# CLEVELAND NATIONAL FOREST POWER LINE REPLACEMENT PROJECTS

# A Sempra Energy utility MINOR PROJECT REFINEMENT REQUEST FORM

| <b>Date Submitted:</b>   | 10-16-17               |           | Request #:        |             | 010       |            |            |

# ATTACHMENT B: SURVEY AREA MAP

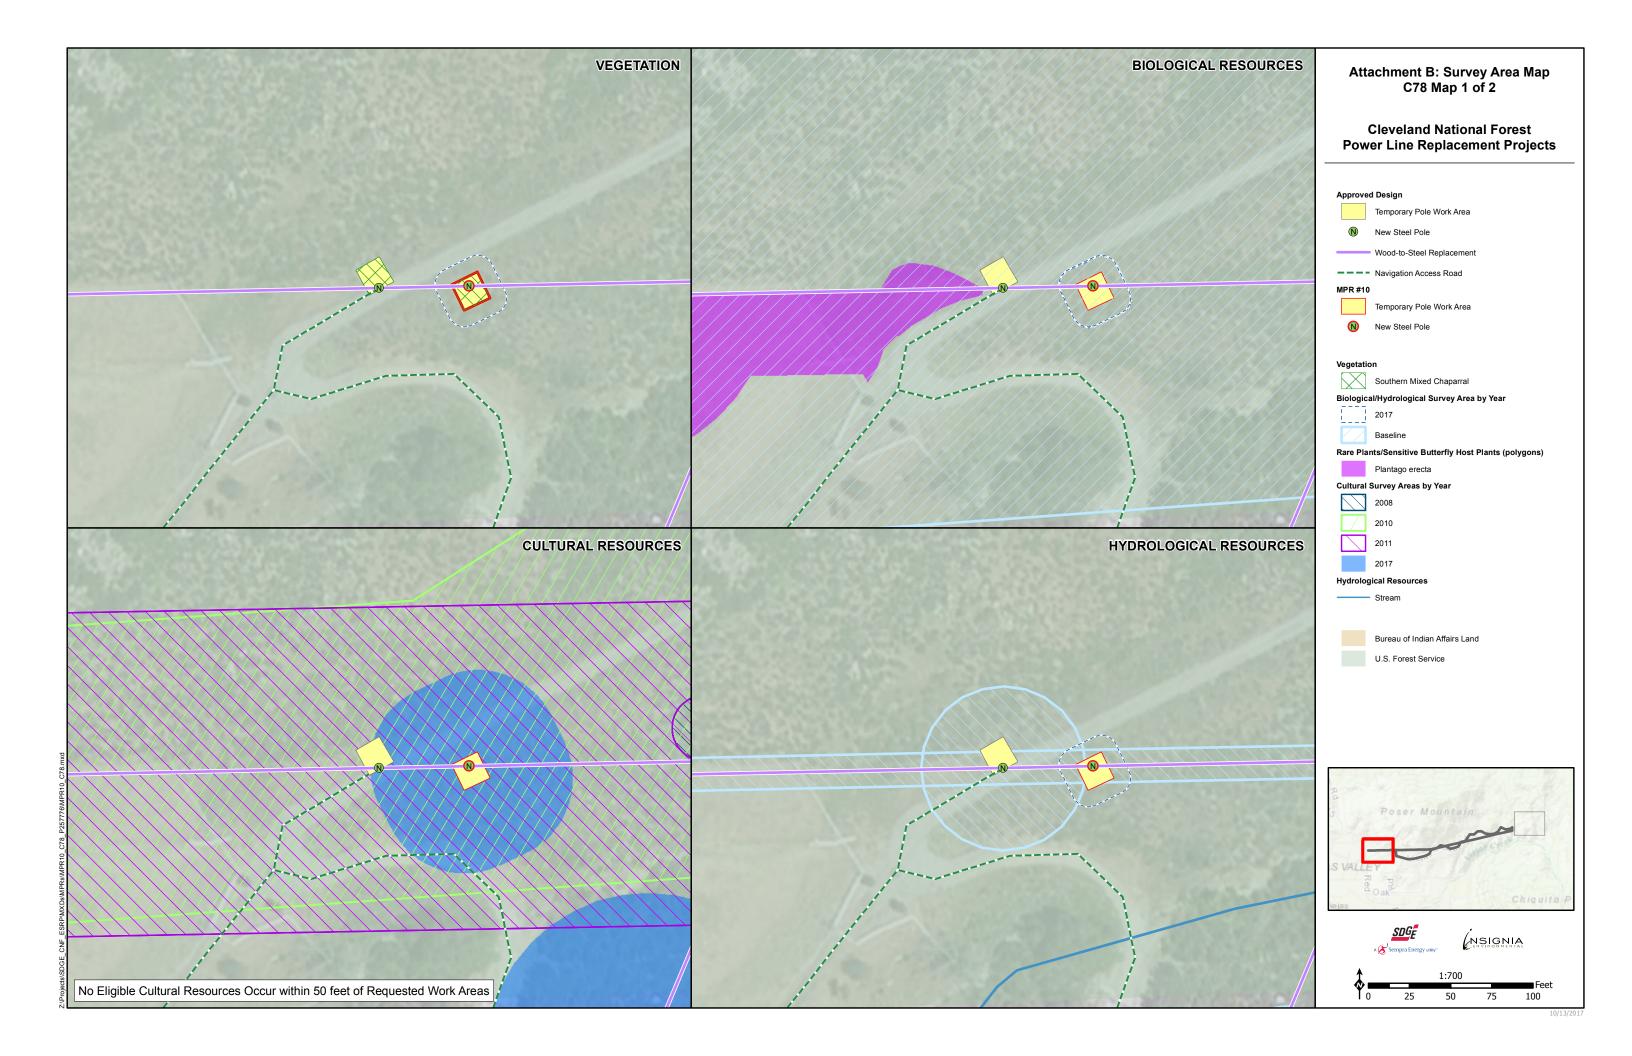
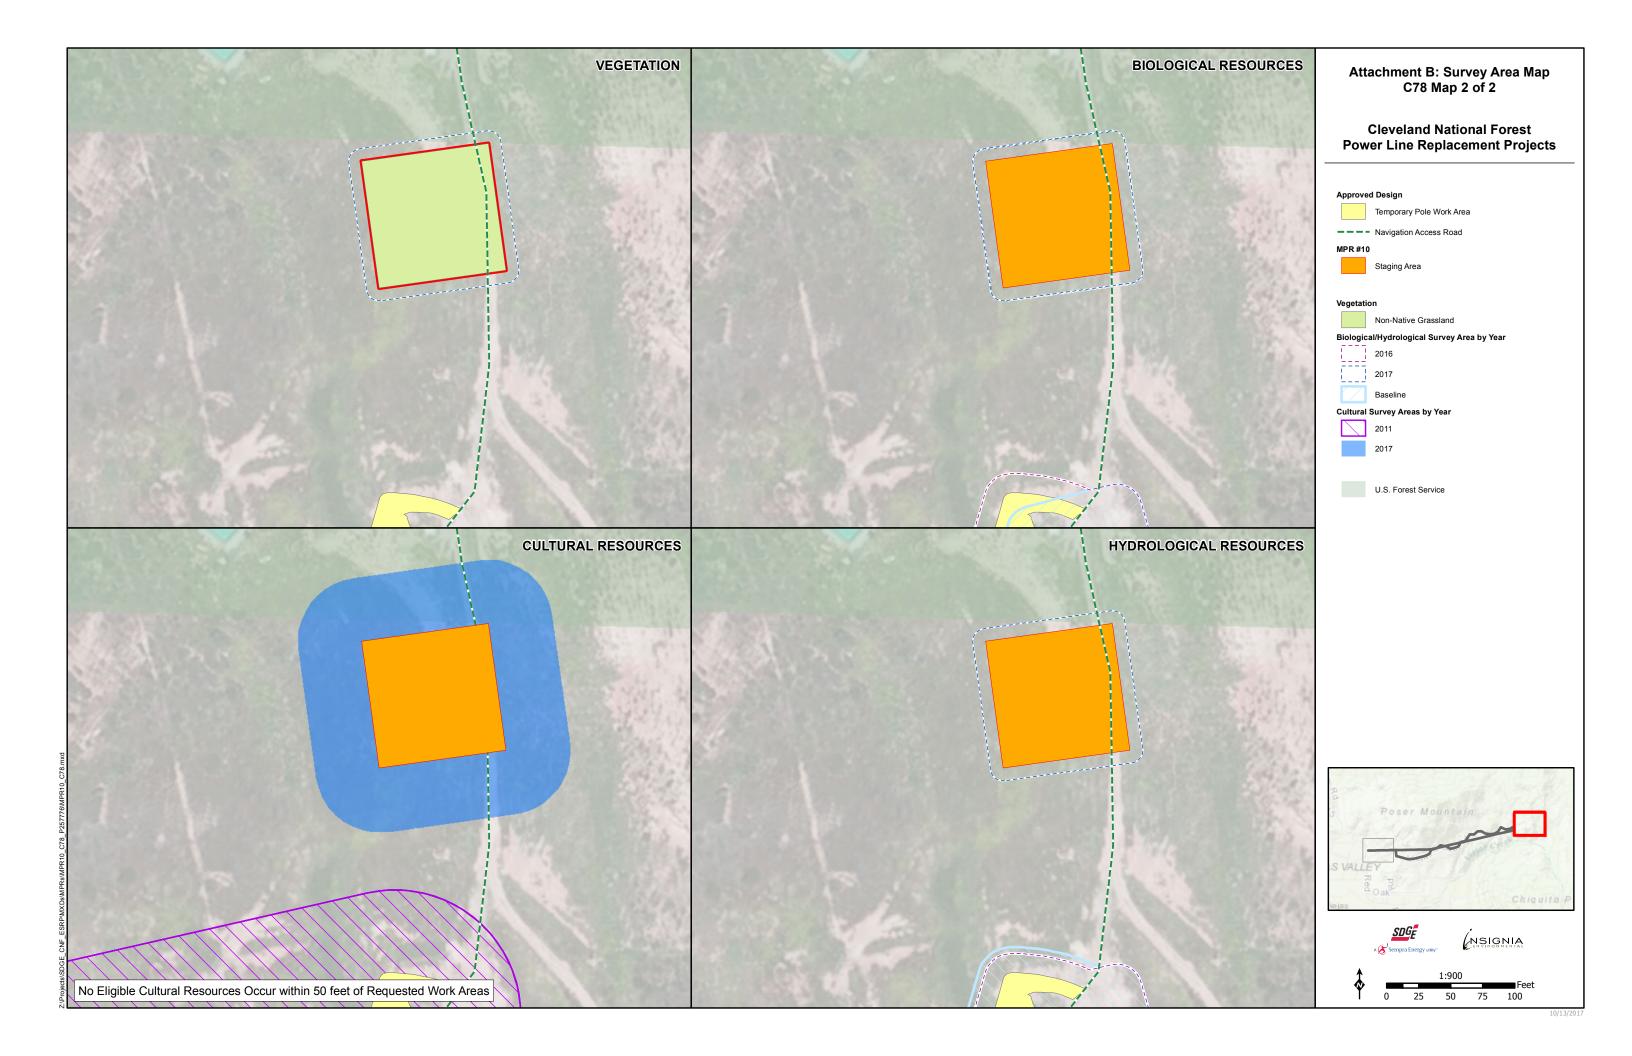
| (d) Does the proposed refinen  | nent trigger an additi   | onal permit requirer                               | nent?              |         | □ Yes                   | ⊠ No     |  |
|--|--|--|--------------------|---------|-------------------------|----------|--|
| As depicted in Attachment B: Survey Area Map and Attachment C: Photographs of this MPR request, SDG&E proposes to add a staging area just north of the eastern terminus of the C78 alignment and shift Pole P257776 approximately 50 feet east of its approved location to the eastern side of Red Oak Road. The temporary pole work area associated with Pole P257776 will also move approximately 50 feet southeast, but will remain approximately the same size and configuration. The requested staging area is located approximately 309 feet north of Pole P172713 and will be accessed using an existing, approved navigation road. Mowing will be required for use of the staging area, which is approximately 0.23 acre of non-native grassland. The staging area will be used for approximately two months. The activities associated with the construction and utilization of the refinement areas will be consistent with the project description as detailed in the Final EIR/EIS.  The requested refinements will result in an increase of up to 0.24 acre of temporary impacts, of which approximately 0.01 acre is classified as Southern Mixed Chaparral. |  |  |                    |         |                         |          |  |

| (d) Does the proposed refinen  | nent trigger an additi   | onal permit requirer                               | nent?              |         | □ Yes                   | ⊠ No     |  |
|--|--|--|--------------------|---------|-------------------------|----------|--|
| The staging area is being requested to provide an additional area for vehicle parking and turnaround, as well as additional storage for materials and equipment adjacent to the Project's right-of-way (ROW). Because the C78 Fly Yard, which was previously approved in MPR #5, is no longer available due to its change in ownership, the additional staging area is needed. The staging area was selected due to its accessibility from an existing, approved navigation road, as well as its minimal slope and current vegetation cover (i.e., predominantly non-native grasses).  SDG&E is requesting to shift Pole P257776 per the landowner's request. The location for Pole P257776, as  |  |  |                    |         |                         |          |  |
